ADDENDUM

PROJECT: Eastridge Presbyterian Church
Phase II - Education Wing Renovation
Lincoln, Nebraska

AD-3

DATE ISSUED: Monday, May 7, 2012

From Sheet: A-101 for CA use:
 Drawing # A-101.1

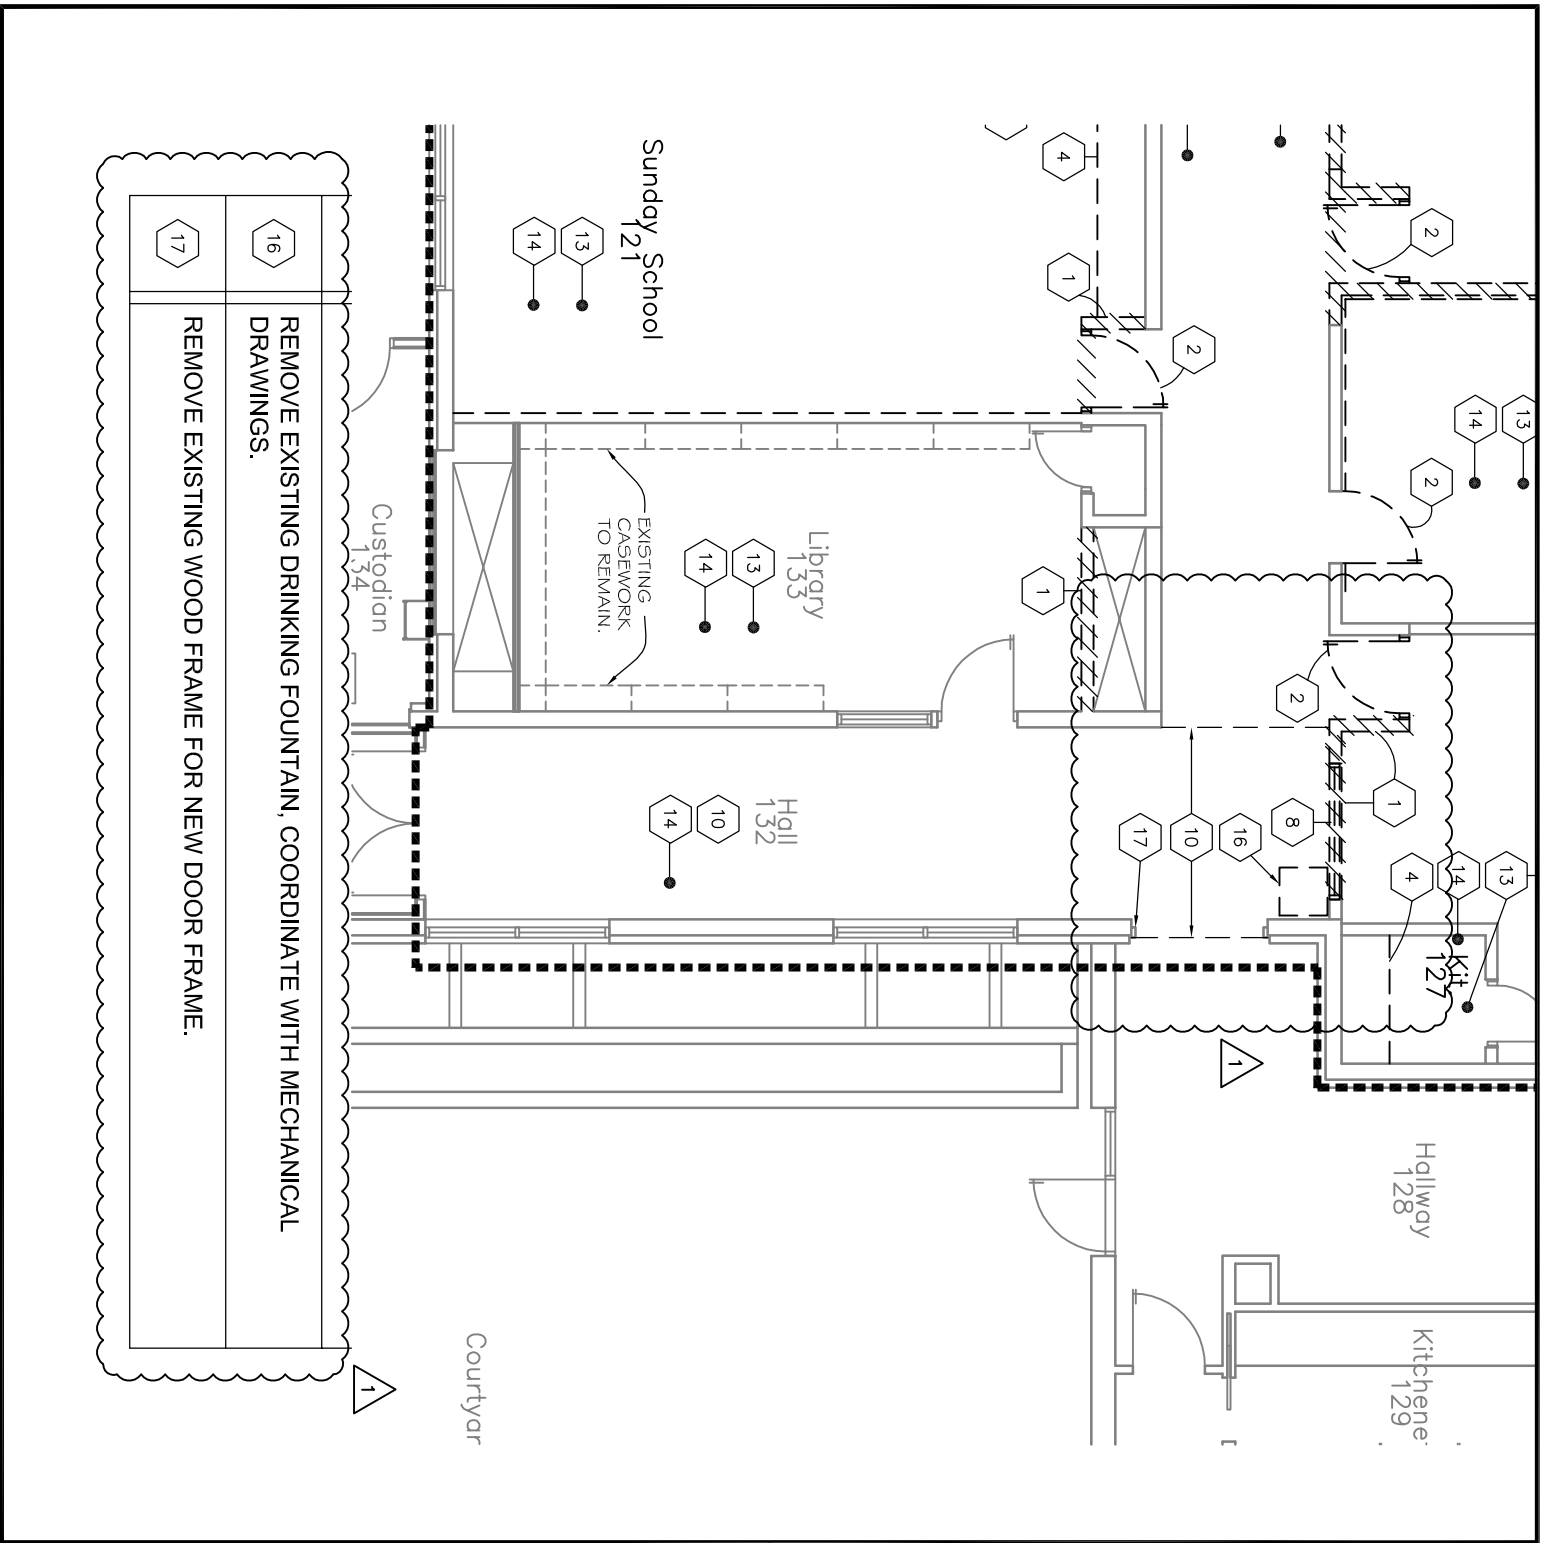
In reference to drawing Sheet A-101, see attached supplemental drawing A-101.1 showing drinking fountain to be removed, wood door frame to be removed, and the extent of flooring to be removed in Hall 132. The flooring removal should be coordinated with the flooring abatement (under a separate contract) that is to be done in Hall 123.

Issue Date	05-07-2012
Job #	12-0040
Drawn by:	DRS
CADD file:	P-103
COPYRIGHT © DAVIS DESIGN ALL RIGHTS RESERVED	
Drawing Title	
Basement Plumbing Plan	
From Sheet:	for CA use:
P-103	
Drawing #	
P-103.2

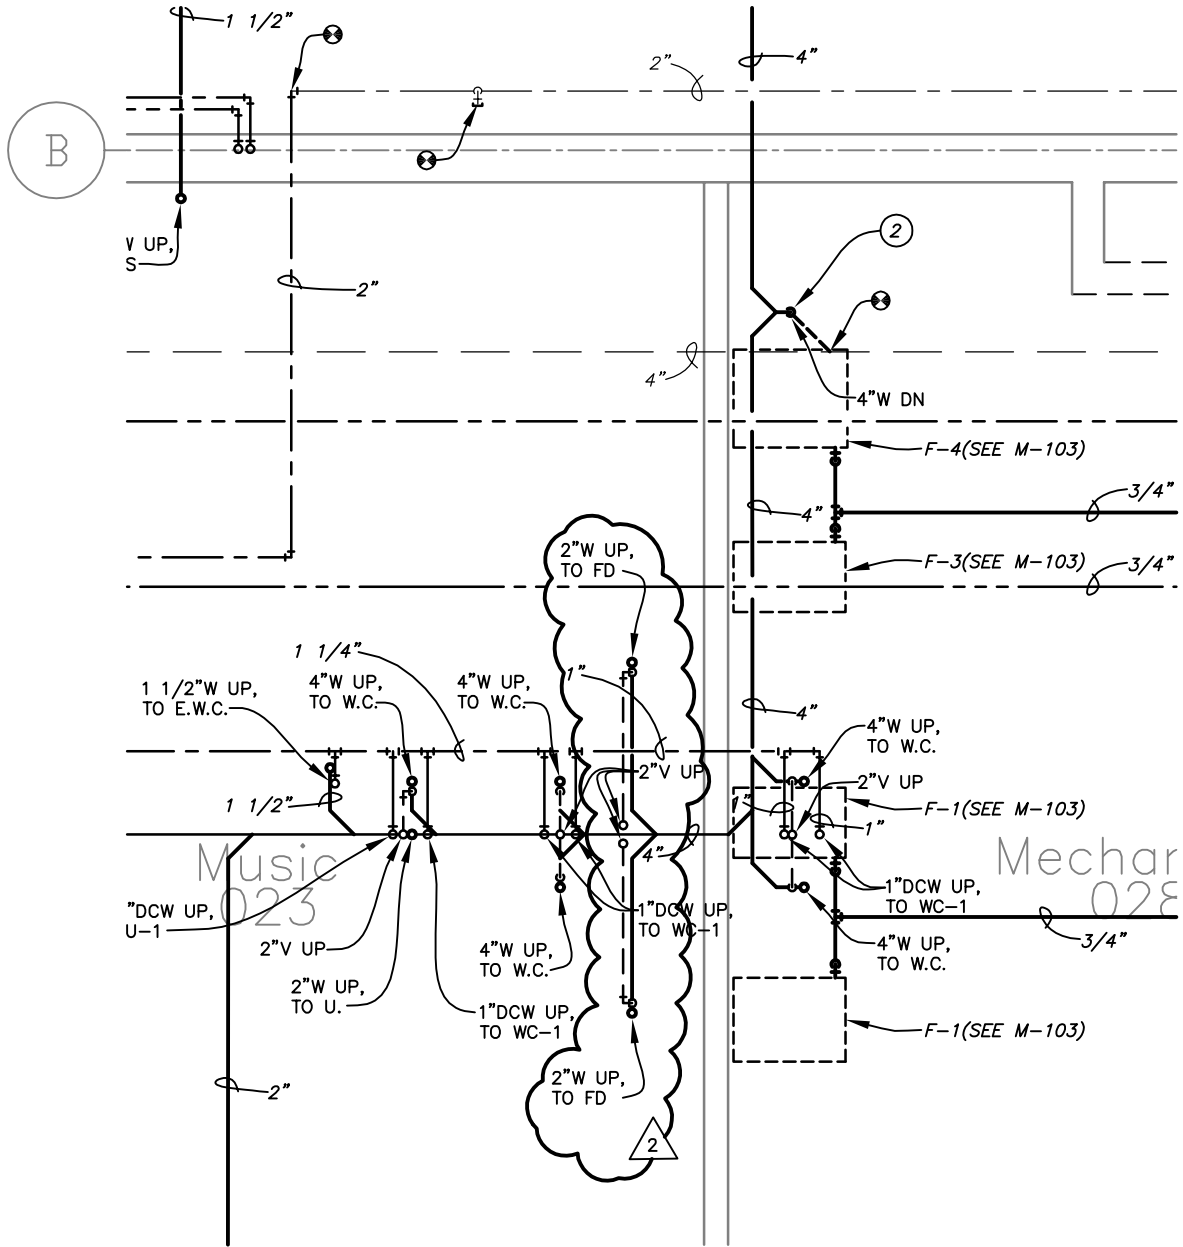
In reference to drawing Sheet P-103, add waste and vent piping for floor drains above, see attached drawing P-103.2

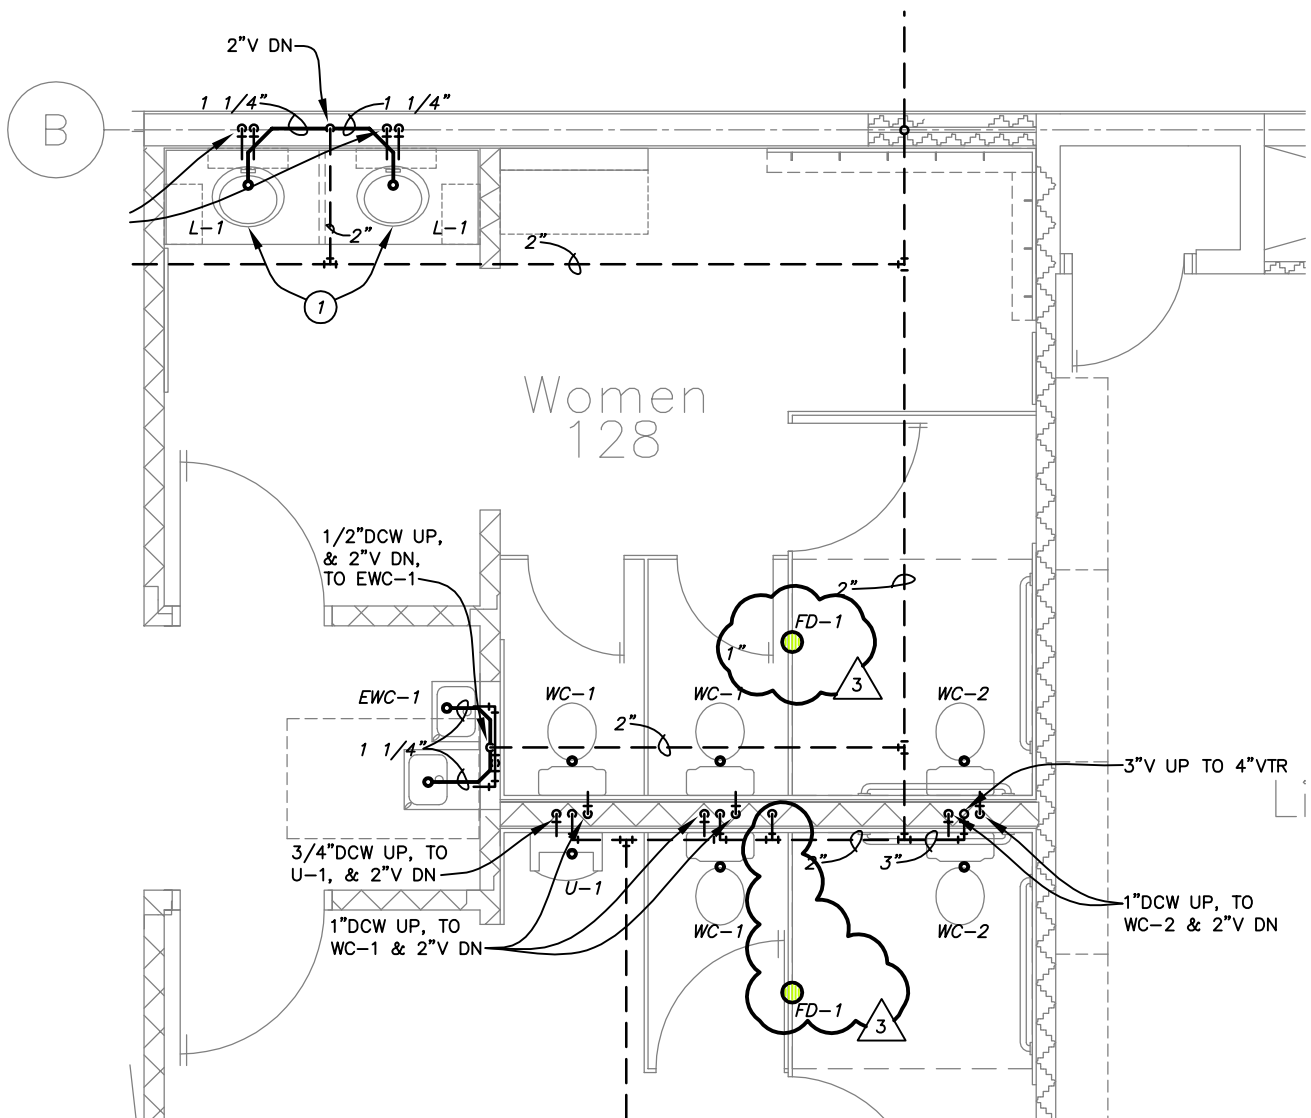
In reference to drawing Sheet P-104, add floor drains to the restrooms as shown on attached drawing P-104.3.
